In Re : RICHARD E. FORKEY AND WILLIAM P. BARNES, JR.
AND ROBERT N. ROSS AND JOSEPH N. FORKEY
Serial No. : 10/809,198
Filed : March 25, 2004
FOR : OPTICAL DEVICE WITH LENS POSITIONING AND
METHOD OF MAKING THE SAME
EXAMINER : Loha Ben
ART UNIT : 2873

AMENDMENT TO THE DRAWINGS

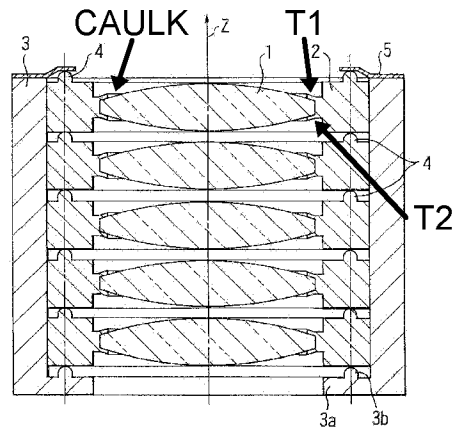
The Examiner rejects claims 1 and 2 under 35 U.S.C. 102(b) as being clearly anticipated by U.S. Patent No. 6,122,114 to Sudo et al. for an optical-element supporting device and optical apparatus (hereinafter "Sudo"). The Examiner argues that claims 1 and 2 clearly read on FIG. 1 and the disclosure from line 30 of column 3 to line 51 of column 4, citing Sudo. The Examiner further stated that reference should be made to numerals 1 and 2 that are arranged on the Z axis, where the detailed configuration and arrangement impart every feature recited in claims 1 and 2 with numeral 1 corresponding to the optical element, and numeral 2, to the optical element support means of claims 1 and 2.

The above copy of FIG. 1 is annotated with three additional notes. The "CAULK" portion appears to be added to the lens surface at the ends of tangs T1 and T2. If the caulking is removed from the material, tangs T1 and T2 still appear to support the lens 1. The tangs T1 and T2 seem to have a substantial thickness. Insofar as Applicants can determine, Sudo does not describe how the lens 1 is placed in the ring frame 2 given the overlap of the tangs T1 and T2 with the edge of the lens 1. It is not clear how lens 1 with a first diameter is placed in the ring when the tangs T1 and T2 define a smaller diameter.

Even if there is some way of doing that, Applicants respectfully submit that claim 1 and depending claim 2 are patentable over Sudo by clearly defining the optical element support as an integral support that contains a first portion and second plastically deformed spaced portions. Applicants respectfully submit that the tangs T1 and T2 in the figure do not constitute plastically deformed portions of the ring frame 2. Therefore, Applicants respectfully submit that claims 1 and 2 do define an invention that is not disclosed in Sudo and would not be obvious in the Sudo.

FIG. 10

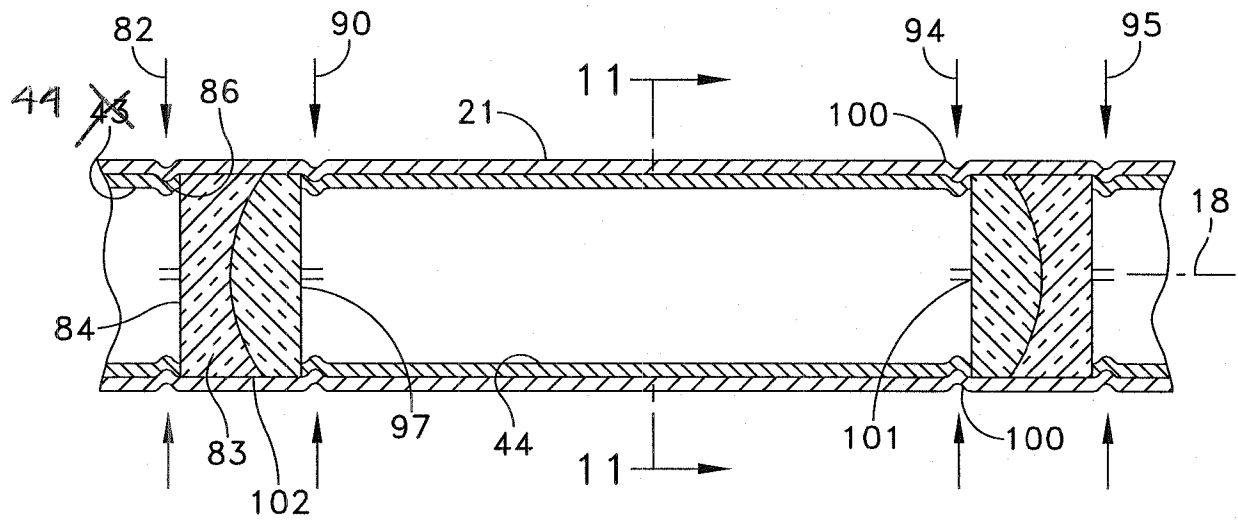
The Examiner notes that in FIG. 10 it appears the numeral "43" at the top left corner should be -- 44 --. Applicants are submitting an Amendment to the Drawings to correct this error.

Please amend FIG. 10 the above-identified patent
application as follows:

Delete "43" and insert -- 44 --.

A copy of the amended drawing is attached. The requested
changes are annotated. Applicants are also submitting a new
formal drawing for FIG. 10.
